These plans have been examined for compliance with the Ontario Building Code. This review has been completed subject to any changes noted, under the condition that the building will be constructed in accordance with the code.

Plan # 27M-47
Address: 234 ANTLER COURT
House model: RUTHERFORD 'A'
Lot coverage 8.4 %
Scale 1:250
Asphalt area 60.6 m²

LOT 31 SITE/GRADING PLAN
WHITE TAIL RIDGE PH. II

Re: Proposed Single Family Dwelling, 234 Antler Court, Lot # 31 White Tail Ridge, Arnprior, Kollaard Associates File # 210055

REAR ELEVATION A, C, D & E

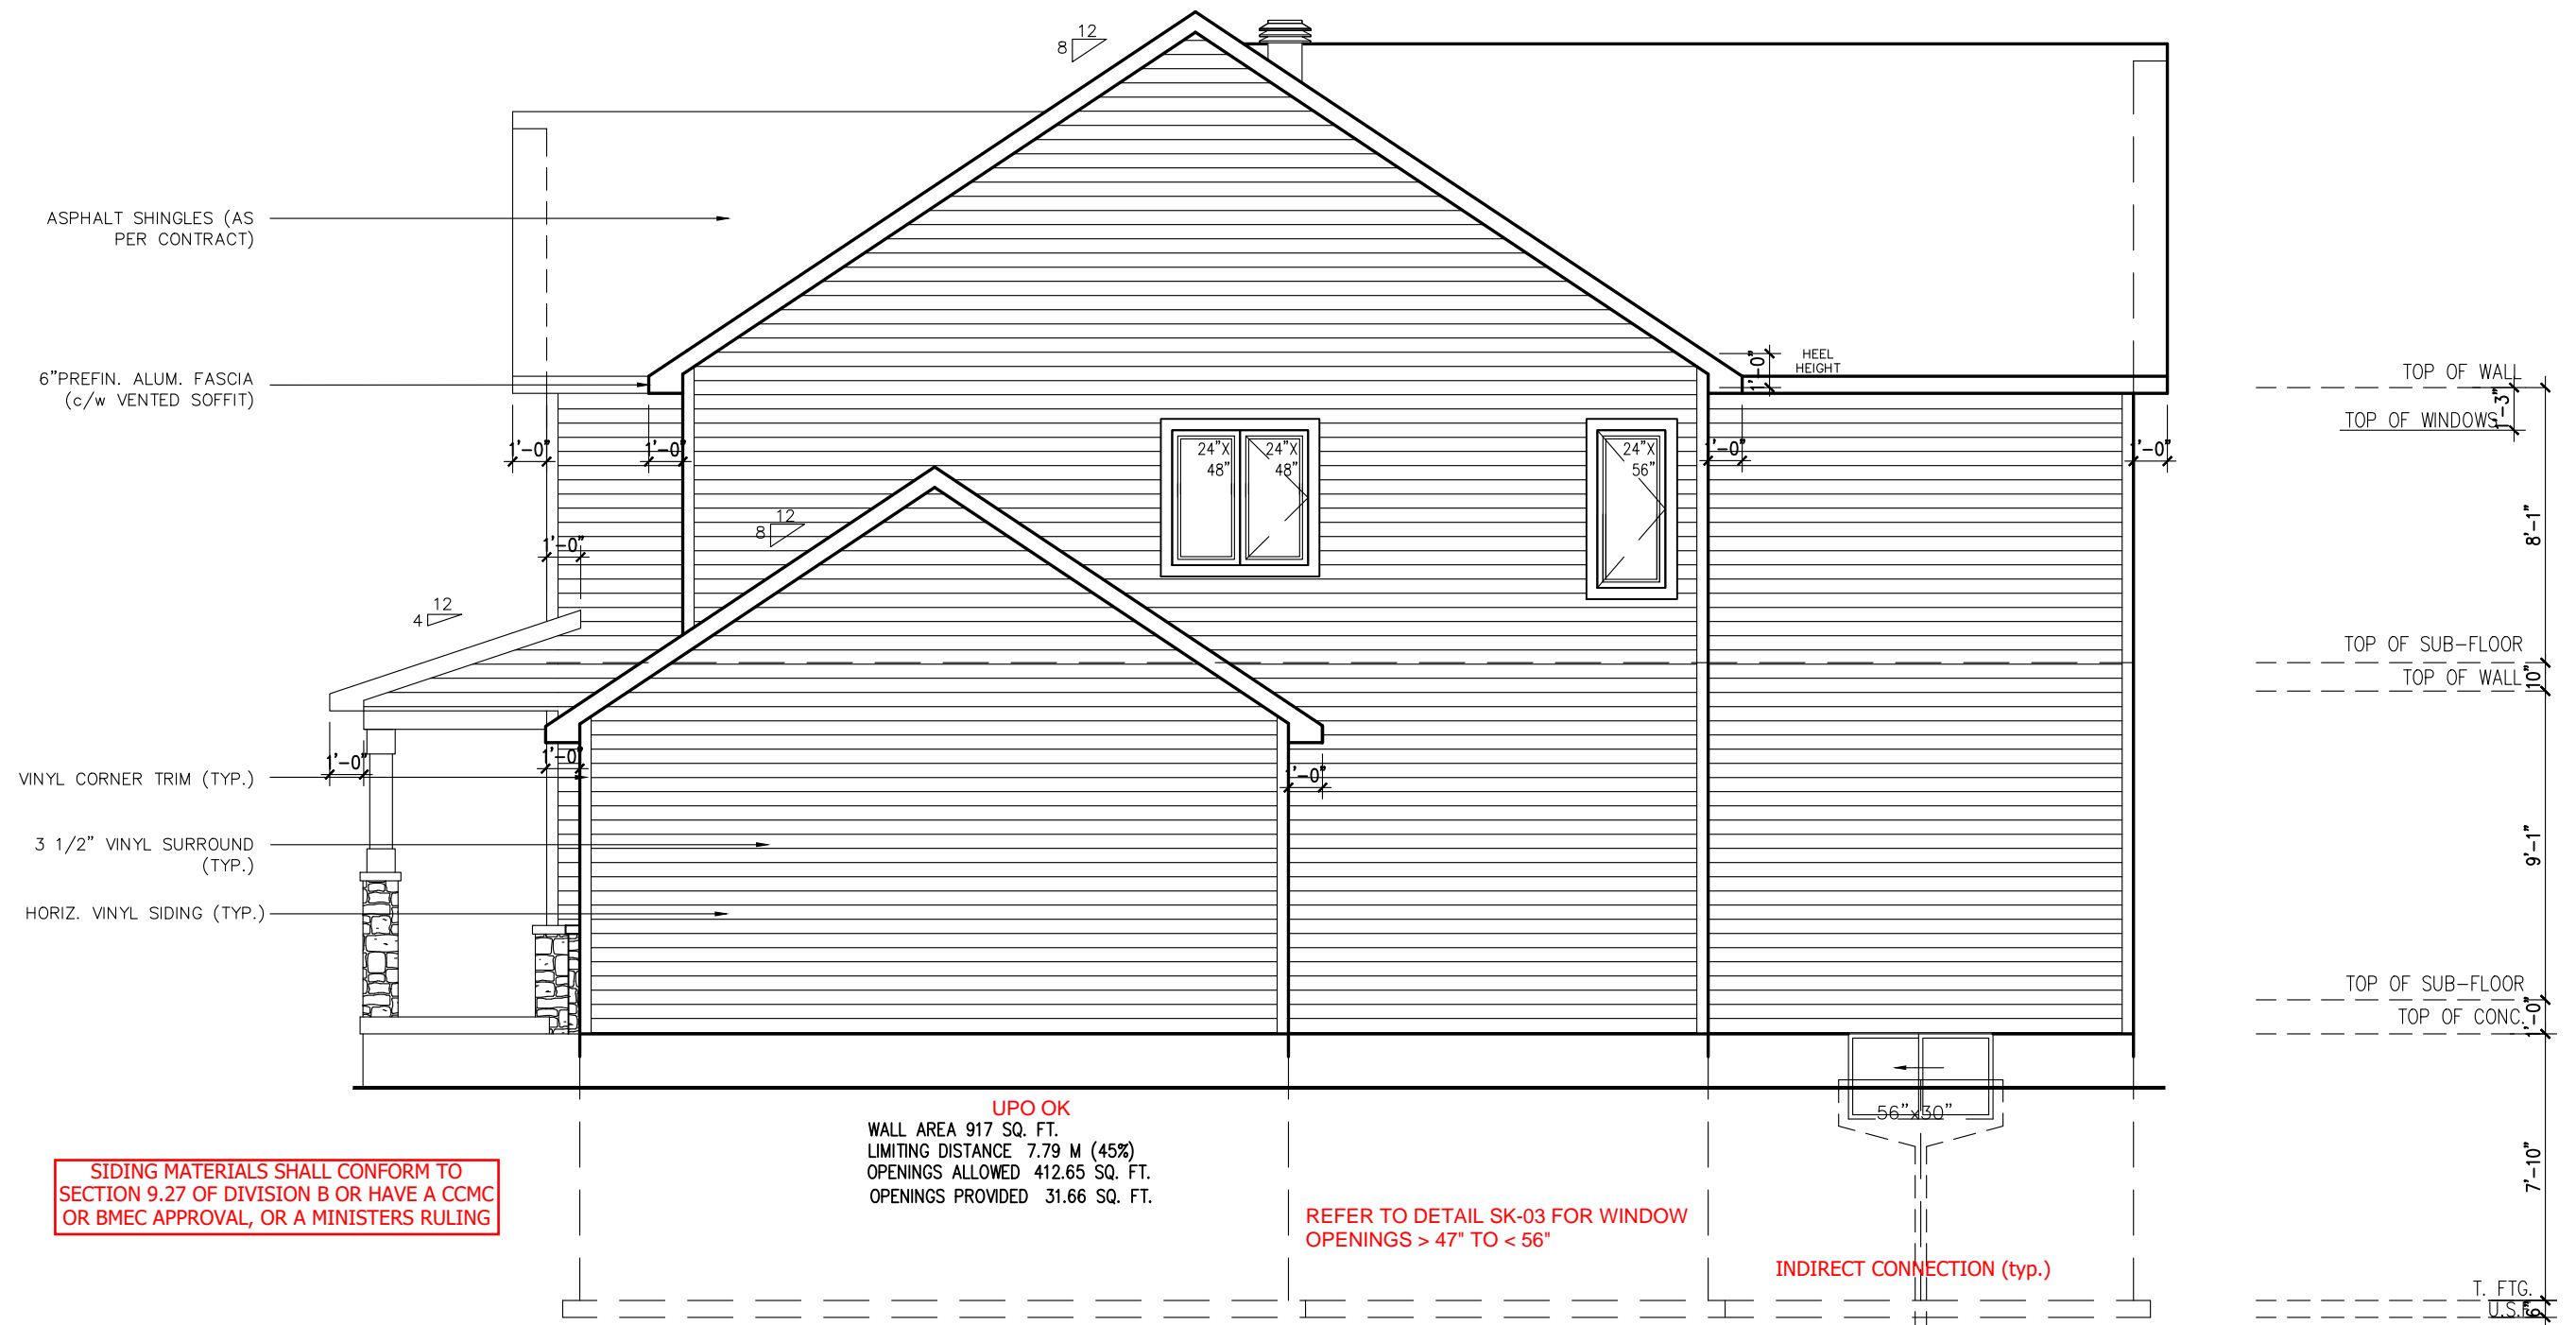
ALL GUARDS TO COMPLY WITH SB-7 OR P.ENG DESIGN.
GUARDS TO BE MIN. 36" HIGH (900mm). WHERE DECK
WALKING SURFACE TO FIN. GRADE EXCEEDS 5'-11"
(1.8m), GUARD HEIGHT TO BE 42" HIGH (1.2m)

RAILING AS PER ATTACHED SB-7 DETAILS OR
ENSURE P.ENG STAMPED RAILING
DOCUMENTATION AND ATTACHMENT DETAILS
ARE AVAILABLE FOR REVIEW BY THE INSPECTOR

ALL GUARDS MUST BE NON-CLIMBABLE WITH
NO HORIZONTAL MEMBERS BETWEEN 5 1/2" AND
35" ABOVE THE FLOOR OR WALKING SURFACE.

REFER TO ATTACHED
ENGINEERED DECK BRACKET

JOB:
PHOENIX HOMES
WHITE TAIL RIDGE
WTR-31
RUTHERFORD A
2ND FLOOR 2 OF 2

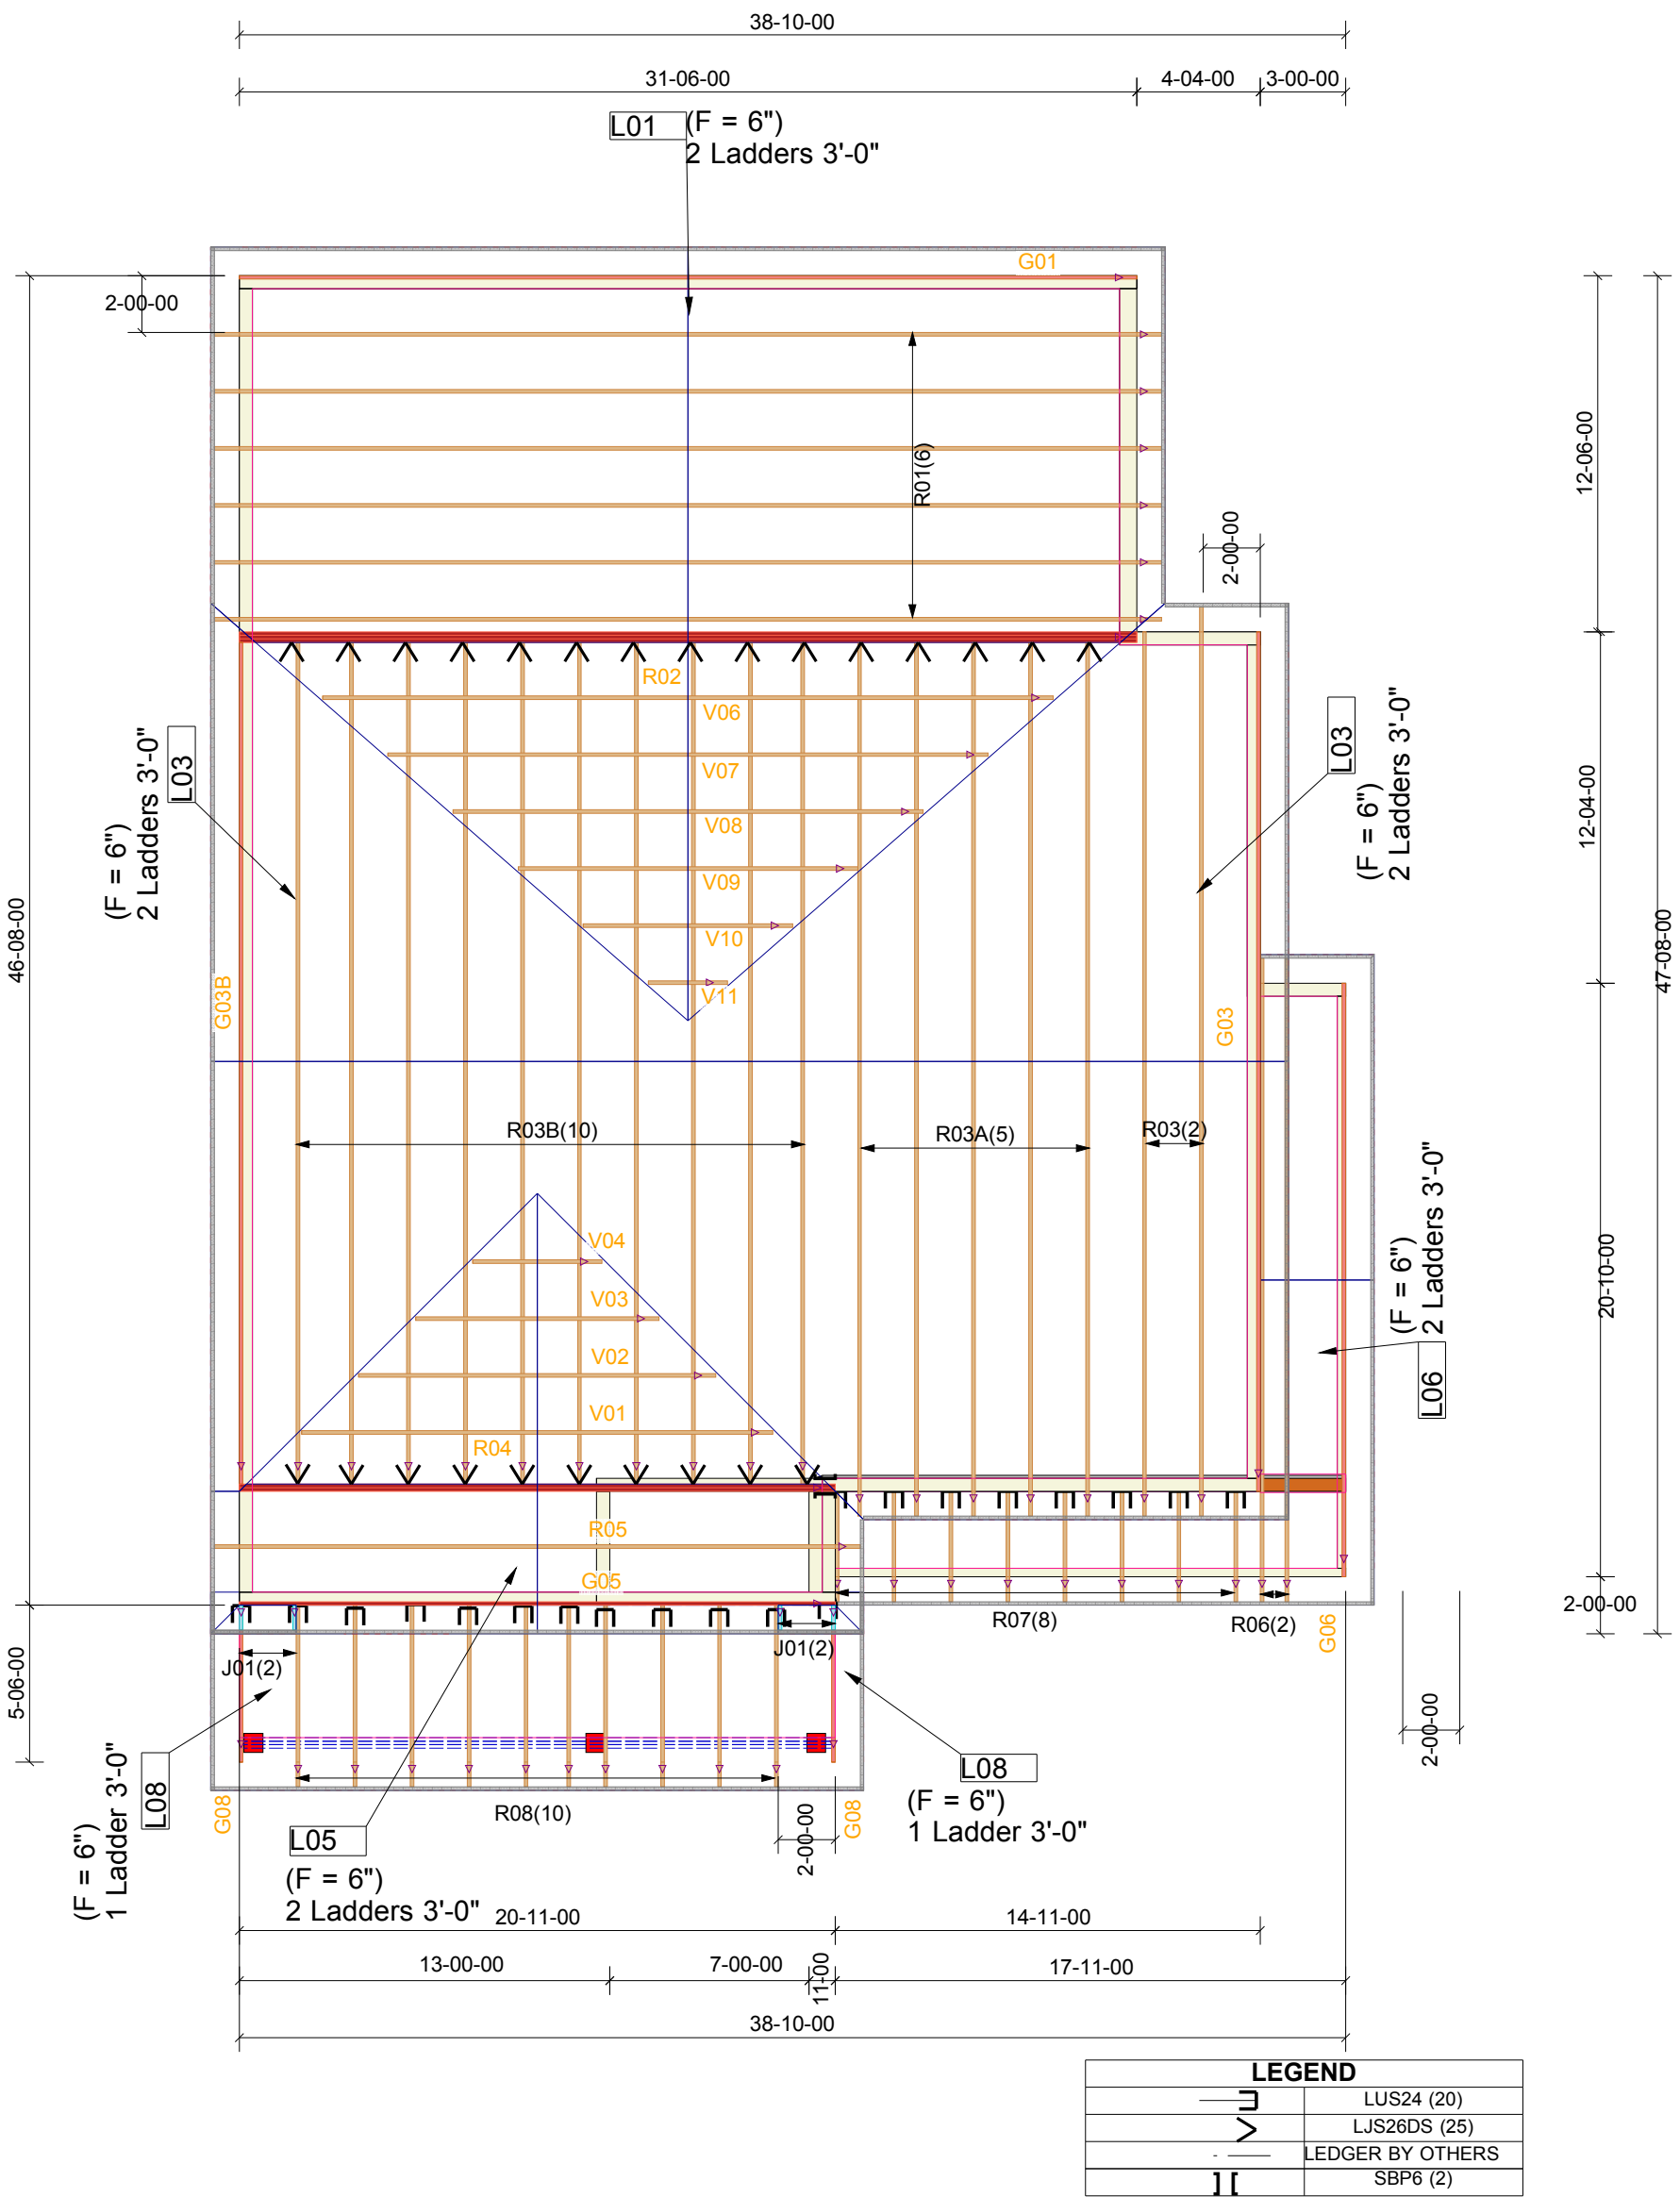
DETAILS SEALED BY A PROFESSIONAL ENGINEER ARE REQUIRED FOR THE LVL BEAMS ON FRAMING INSPECTION

TRUSS AND ENGINEERED FLOOR DRAWINGS SEALED BY A PROFESSIONAL ENGINEER ARE REQUIRED ON FRAMING INSPECTION

ANY OPENINGS IN FLOOR WEB FOR PLUMBING, HVAC AND ELECTRICAL TO MEET THE MANUFACTURERS SPECS. P.ENG REPAIRS MAY BE REQUIRED IF HOLES ARE TOO LARGE, TO CLOSE TOGETHER OR TOO CLOSE TO THE EDGES.
